Questions from Chair McMahon with responses from Staff in red.

Docket Item #16 DSUP #2025-10001 2601 Cameron Street

Re: George Mason Elementary School Tree Removal summary analysis: 2601 Cameron Mills Road
IMEG# 24005288

Surface Parking and Drive Aisle Detailed Breakdown

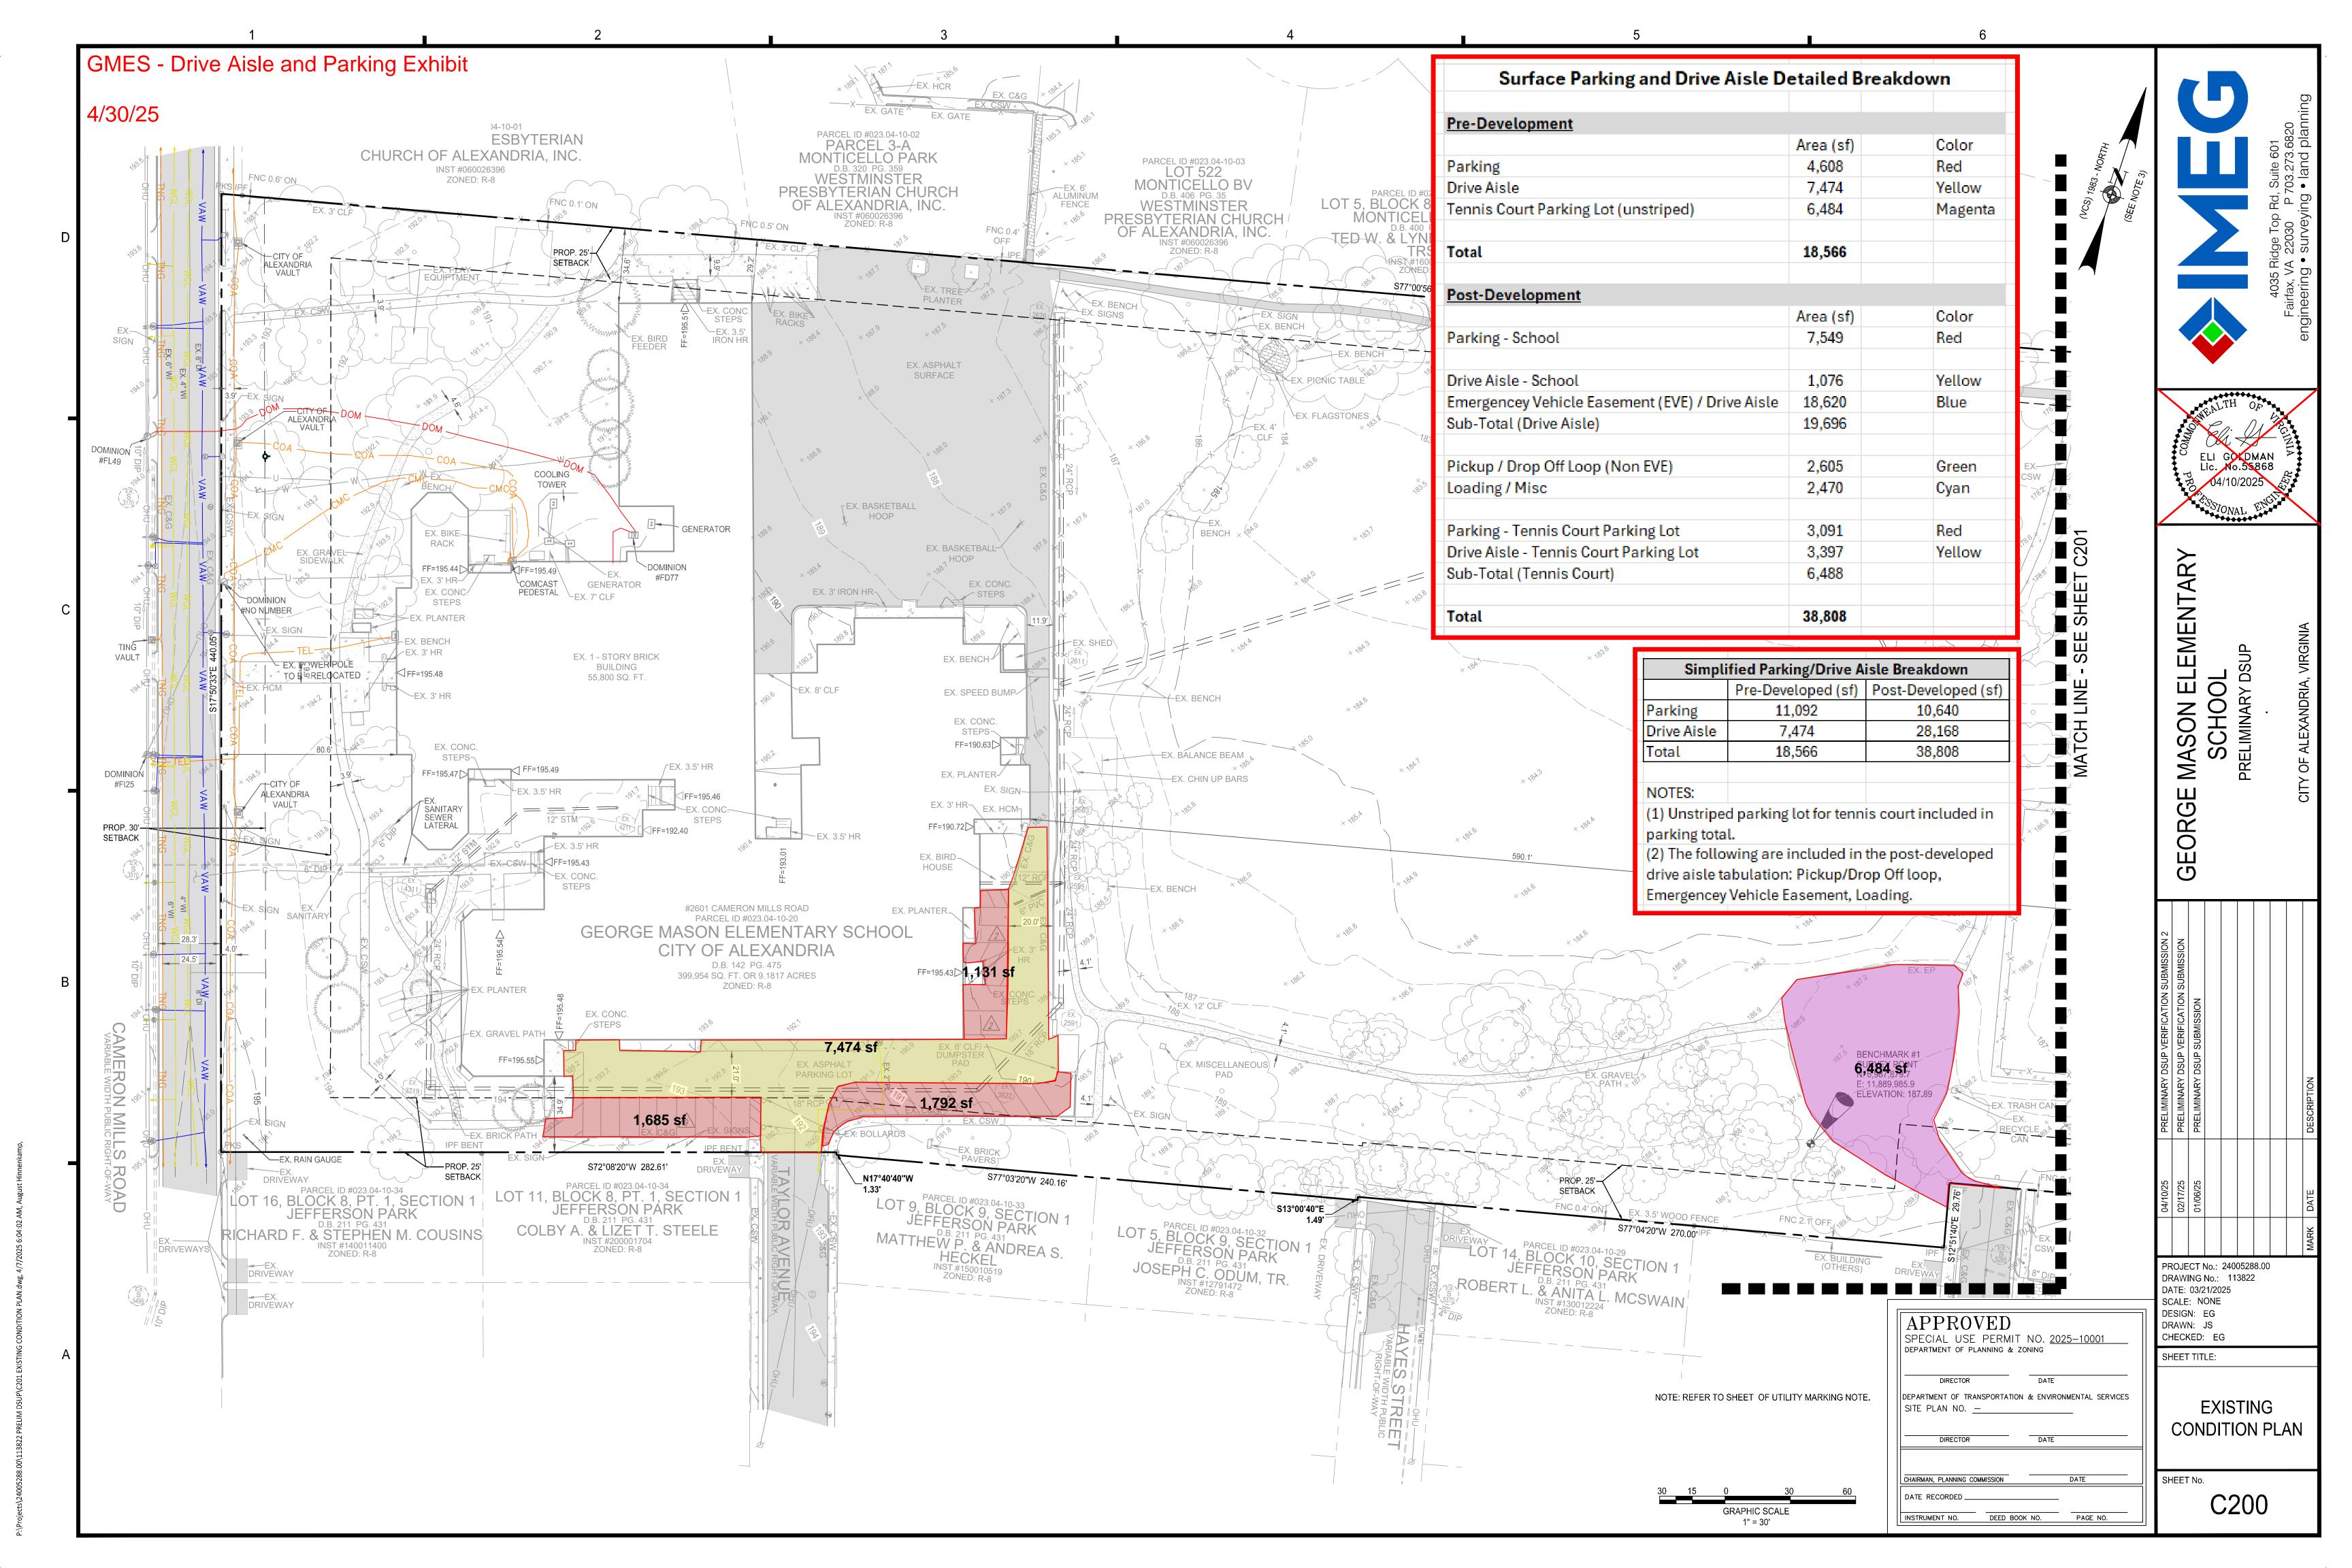
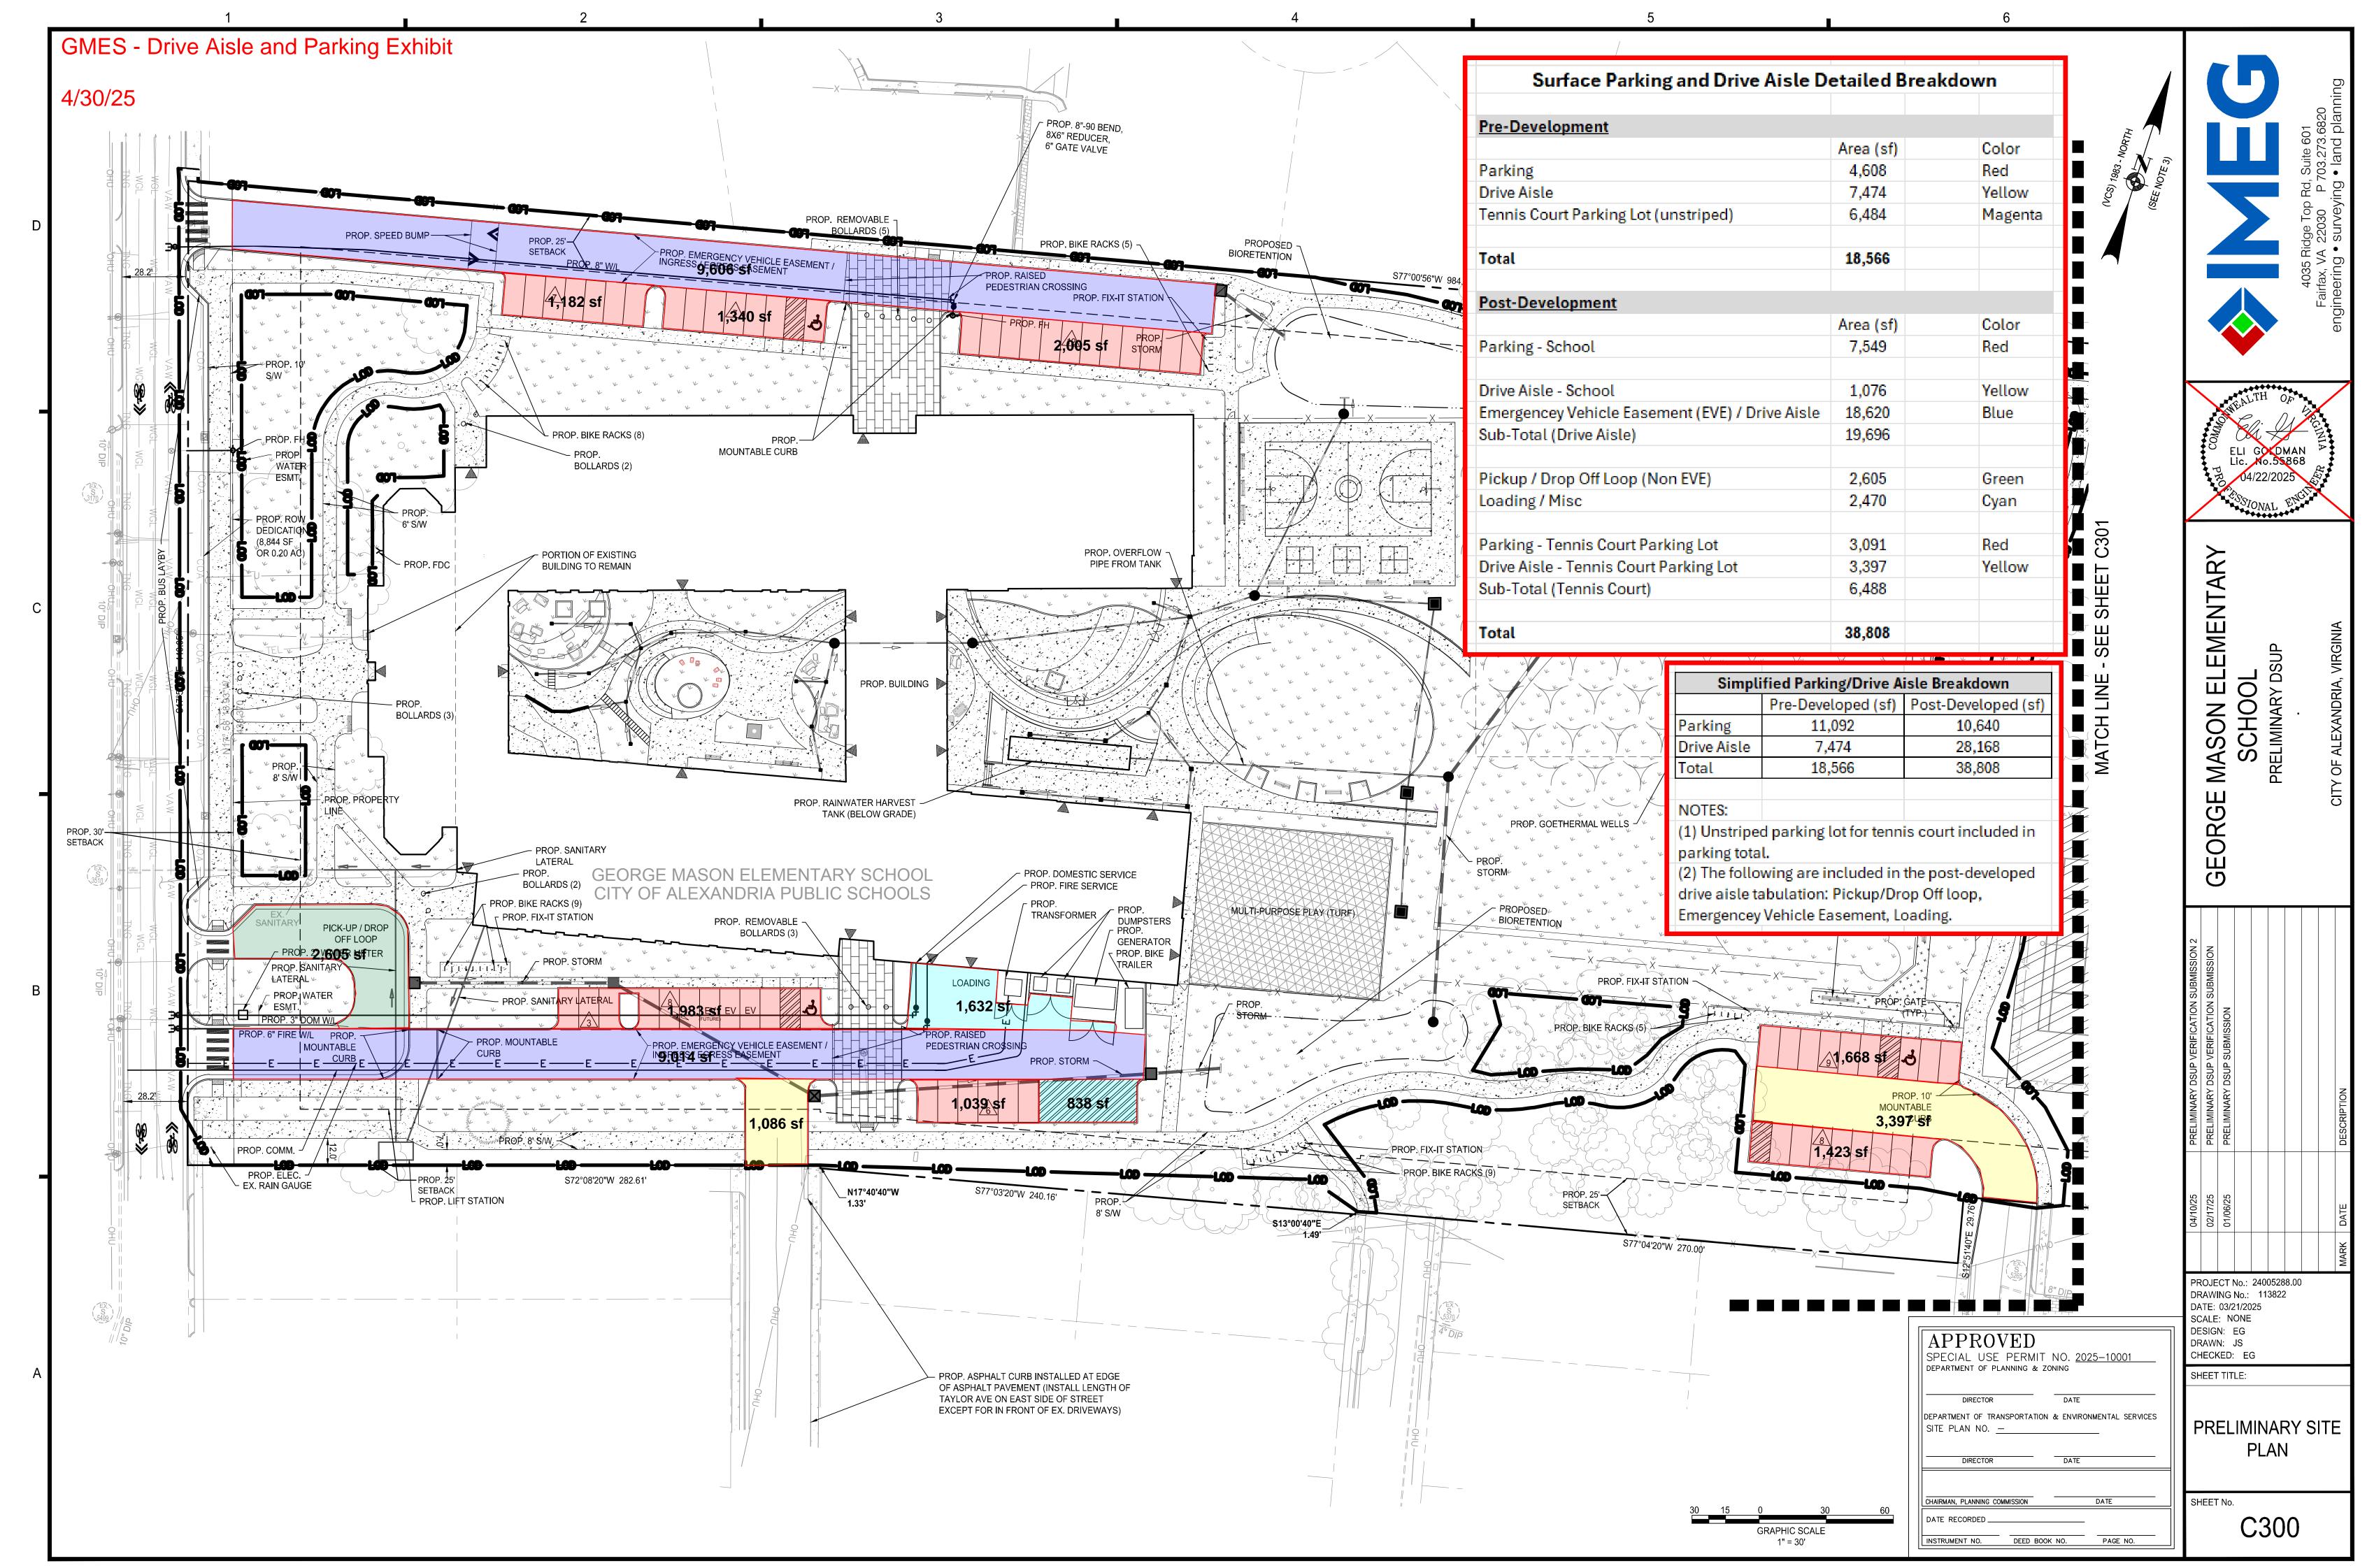
1. What is the total site area, before and after renovation, dedicated to surface parking or drive aisles?

Attached is an exhibit that shows the areas dedicated to surface parking and drive aisles. There is a detailed breakdown provided in addition to a simplified breakdown to help show why there is an increase in impervious area for parking/access. As shown in the exhibit, a lot of the impervious area proposed is needed to facilitate the emergency access for fire trucks around the school. The emergency access to the south and east of the current school barely meets requirements, especially when the parking lot is in use. Access to the north east section of the school is through a green space that has been deemed adequate to support fire truck access and does not count as an impervious area.
